Information Bulletin

430 Diesel Wiring Change

Date: 3/28/2011
Bulletin No: JC-001-11

Issue: Fuel shut-off solenoid and Wire Harness Change

430 DIESEL WIRE SCHEMATIC 75700080569 AND UP

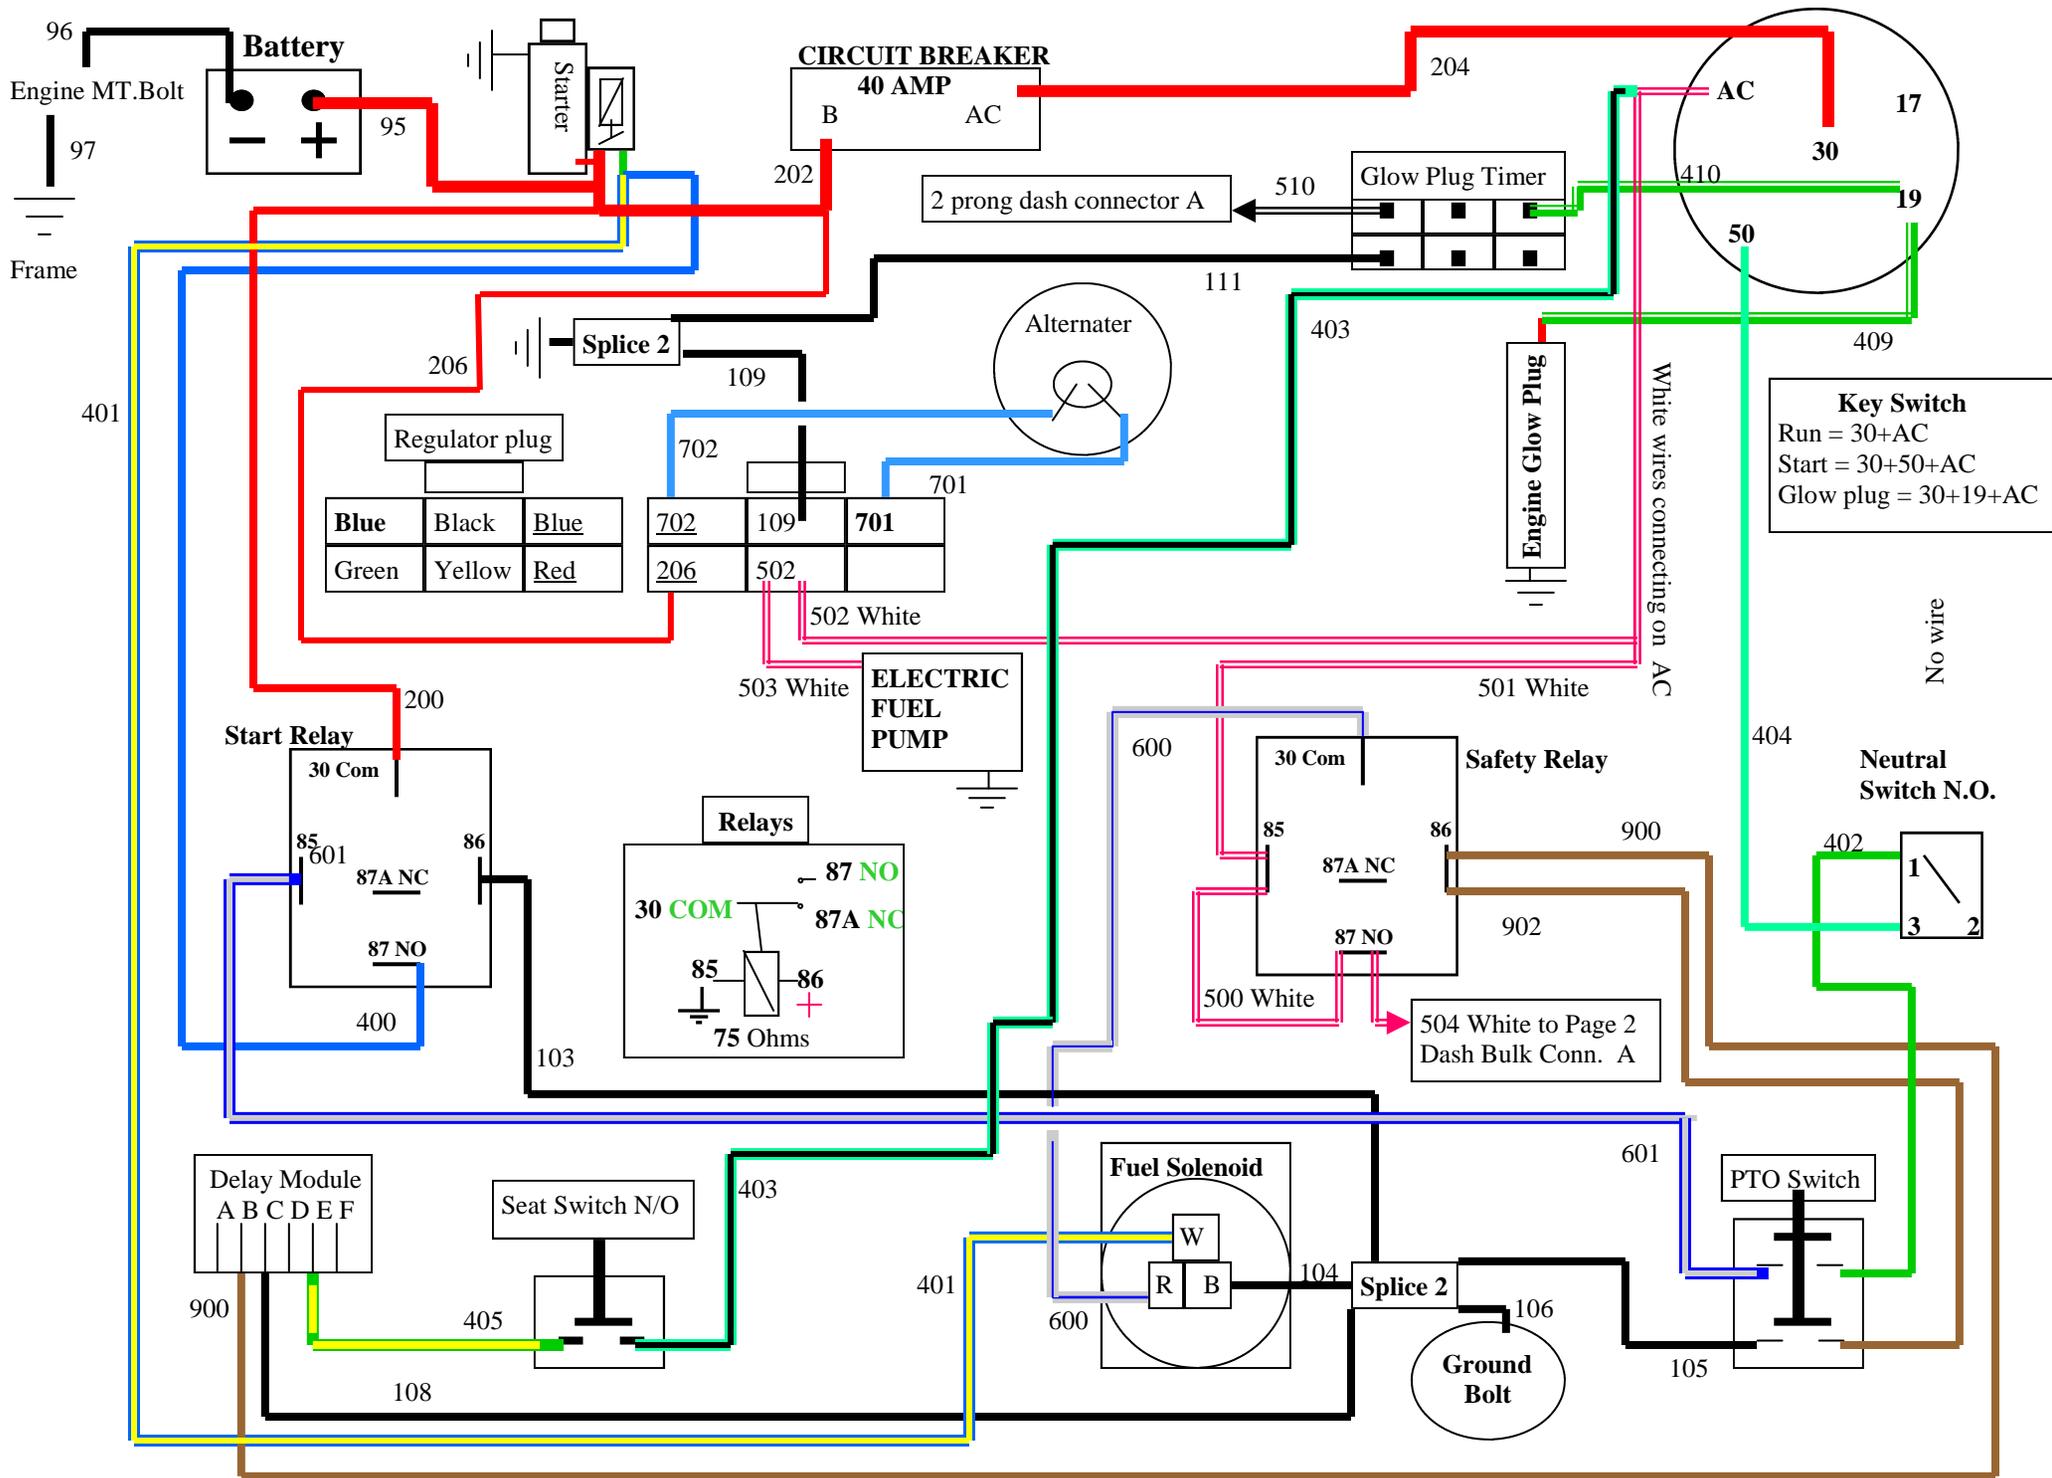
Cause: Schiller Grounds Care has changed the wire harness on the 430 diesel tractors. We have eliminated the fuel shut-off solenoid module and replaced it with a shut off solenoid mounted on the engine; it is hooked right to the shut-off lever on the engine. In addition we are employing a Delay Module, which offers the benefit of keeping the circuit connected for approx ½ second should the operator bounce in the seat. This will prevent interruptions in the fuel supply being cut off intermittently over rough terrain.

When trouble shooting electrical problems, remember the seat switch does not ground out the relay anymore. It now breaks positive flow to the Delay Module.

Kubota Solenoid: MODEL; 1756ES-12SUC5B1S5 P/N; SA-5176-12

430-21D wire harness: 4163085

½ second delay module: 2188154
